Camden Residents' Action Group

General Manager and Council
Camden Council
John Street,
Camden 2570
27 July 2016

URGENT REQUEST FOR MEETING **Argyle St works and health of Jacaranda and other street trees**

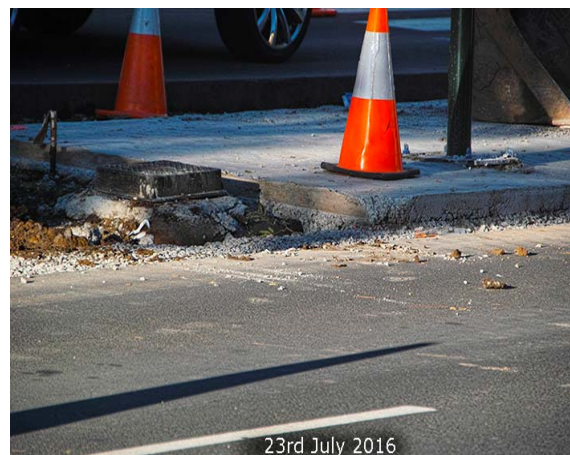
As can be clearly seen in the photos below, the width of the median strip has been reduced, with the new wide strip of concrete around the Argyle Street median strip garden now significantly closer to the jacaranda trunks and covering a larger area of the root systems. One side is closer than the other as the trees were not planted in the centre of the street and the lane widths are not the same.

If there is to be encroachment into the PRZ as is apparent, the Structural Root Zone (SRZ), an area considered essential for tree stability, must not be disturbed. Australian Standard 4970-2009 indicates that a tree with a diameter of 30cms has an SRZ radius of 2 metres.

Encroachment into the SRZ is obviously demonstrated in the photos above and opposite. This raises serious questions about safety and the management of the Argyle St works.

There is a wide trench and concrete inside the kerb line used to facilitate a level path for the machine laying the kerb. The wide concrete is to make a level platform for the kerb making machine to travel on which is convenient for the contractors, but detrimental to the health of the trees. The contractors should be required to

use a concrete saw to remove the excess width of concrete.

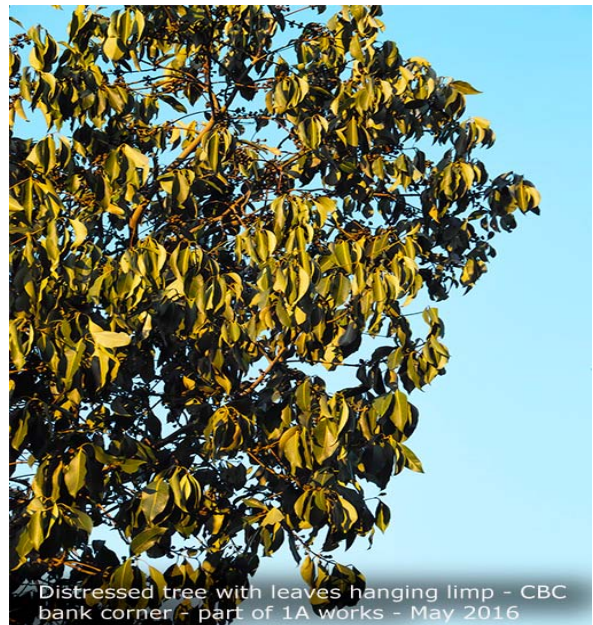
One only has to take note of how the native evergreen box trees (*Lophostemon confertus*) trees on the corners of John and Argyle Street, which are moderately drought tolerant⁴, were affected by the Stage 1A works in the short term through their primary root systems being chopped during the works and changing the area at their bases.

As is clearly demonstrated in the photos above, a third of one tree died and the leaves of another were limp and hanging straight down, not erect as they should be if all was well. Watering by Council truck was not nearly enough for them to survive. Only the heavy rain in June 2016 saved them.

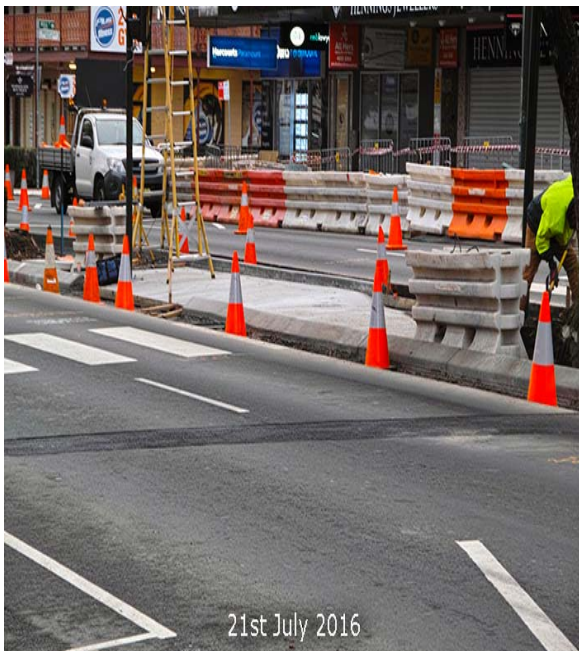
The reduction of open soil surrounds to capture water and interference with the root system of the tree at the Flight Centre corner of John and Argyle Streets during recent

Stage 1B works is yet to become evident.

It also remains to be seen how interference with the root systems, possible changes to soil pH (tolerance pH 4-6)⁵ and reduction of open soil surrounds will affect the healthy survival of the box street trees over time.
